B&W FUEL COMPANY

May 10, 1993

REFERENCE: Certificate of Compliance for Model No. 51032-2,
Docket 71-9252

MODEL 51032-2 SHIPPING CONTAINER
SIDE DROP ANALYSIS

Figure 1 - Strongback Channel

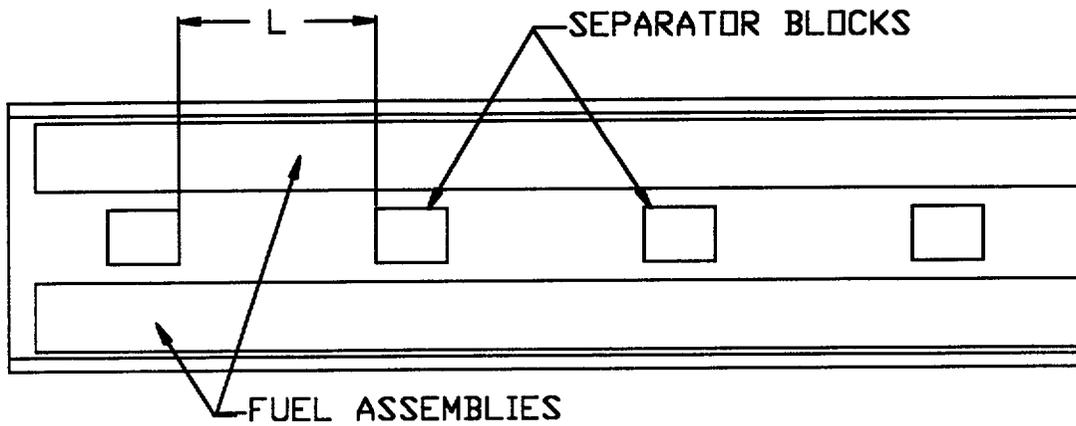
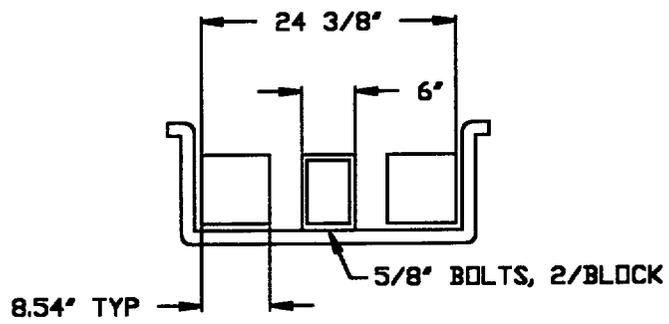
2. The side drop analysis shown in Appendix 1A should be revised to consider the following:
- a. The clear distance between separator blocks required to maintain a six inch minimum separation between fuel assemblies appears to be calculated non-conservatively. The factor L/29 should not be used to reduce the

rotational angle.

- 2a. The clear distance required to maintain a six inch minimum separation between fuel assemblies within the 51032-2 container strongback has been recalculated and is documented in Appendix 1A to this letter. The analysis has also been included as Appendix D to the SAR.
- 2b. The impact force of 82,680 lbs. was conservatively estimated for purposes of examining the strength of the separator bolts, only. A more realistic separator loading analysis was performed and is shown in section 5.3 of Appendix 1A. This is also included in Appendix D to the SAR.

Fuel assembly-to-separator block spacing (See Figure 1), prior to drop, assuming the fuel assembly outer envelope is 8.54 in. for MK-B, can be calculated as follows,

$$(24.375 - (2)(8.54) - 6)/2 = 0.648 \text{ in.}$$

Therefore, $\delta_{\max} \approx 0.648 \text{ in.}$, to maintain a 6 inch minimum fuel assembly spacing.

It is concluded that the maximum "clear" distance between separator blocks required to maintain a 6 inch minimum separation between fuel assemblies is,

$$\therefore L = (0.648/0.00496)^{1/2} \approx \underline{11.4 \text{ in.}}$$

Figure 2 - Separator Block ANSYS Model

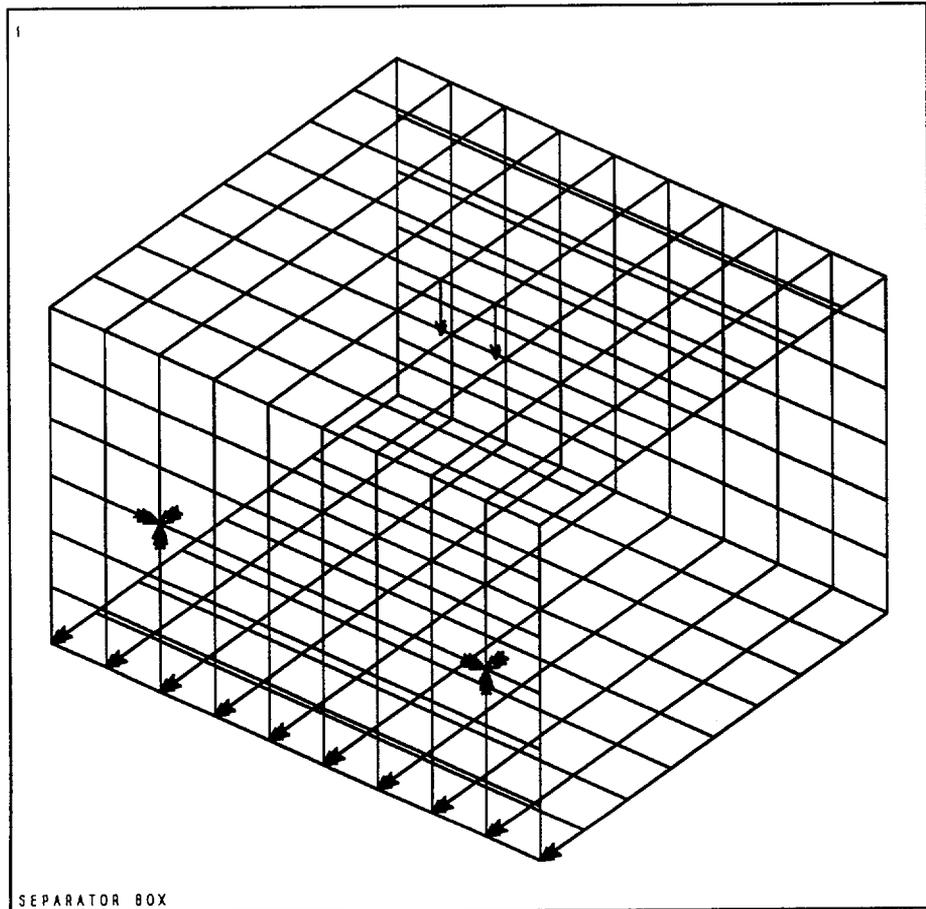
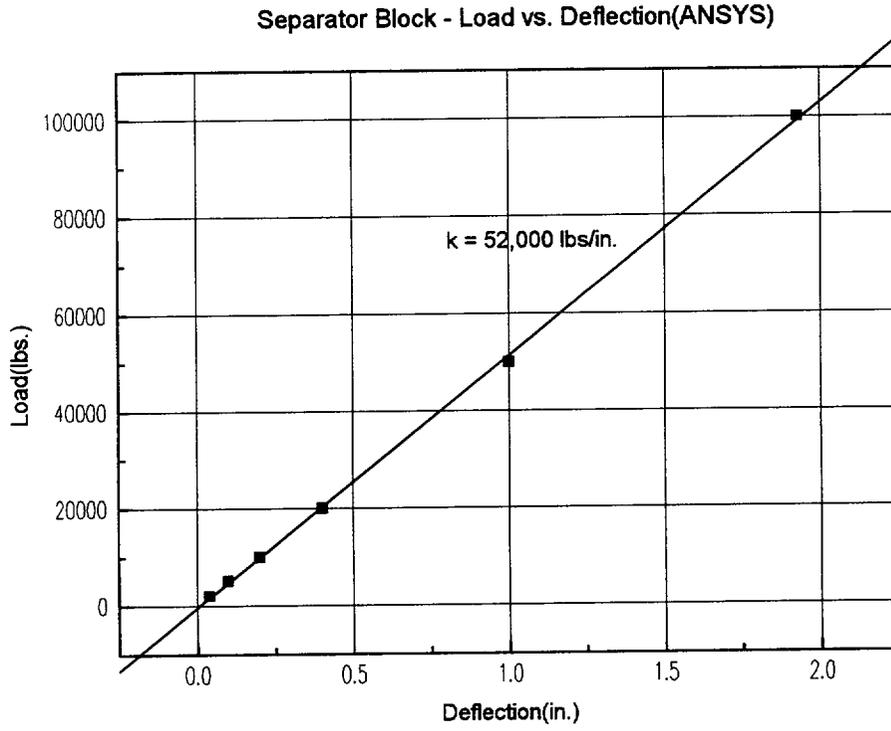
- b. The impact force (82,680 lbs) is too large for the 1/4-inch thick strongback or the 3/8" thick separator block to bear.

A finite element model of the separator block using "shell" elements (STIF 63) was made on ANSYS 4.4A (Ref. 10) to estimate the block stiffness. Loads ranging from 2,000 to 100,000 pounds were applied at the center of one side of the block (nodes 105 & 106), while two points in the approximate location of the bolts were constrained in 6 degrees-of-freedom and the nodes along bottom edge of the block were constrained in the Z-direction to simulate the constraint of the strongback that the block is bolted to (See Figure 2).

The results can be seen in Figure 3 in terms of an apparent linear "Load vs. Deflection", from which the approximate stiffness of the separator block, in its actual orientation, is determined. It should be noted that in this section it is assumed that the strongback and F/A are rigid and do not deflect or absorb energy upon impact. All energy is thus absorbed by the separator block and bolts, where the stiffness of the block is the limiting case. This is also conservative. The calculated stiffness of the block is 52,000 lbs/in. An unrestrained deflection, "x", is then determined for the above stiffness by equating kinetic energy and "elastic" potential energy as follows,

The impact force can then be estimated as follows,

$$F = kx = (52,000)(1.59) = 82,680 \text{ lbs.}$$

$$\tau = 82,680/0.614 = 134,747 \text{ psi. } \gg 78,000 \text{ psi.}$$

$$d_{\text{min}} = ((2)(82,680)/(\pi)(78,000))^{1/2} = 0.821 \text{ in. } \rightarrow 7/8''$$
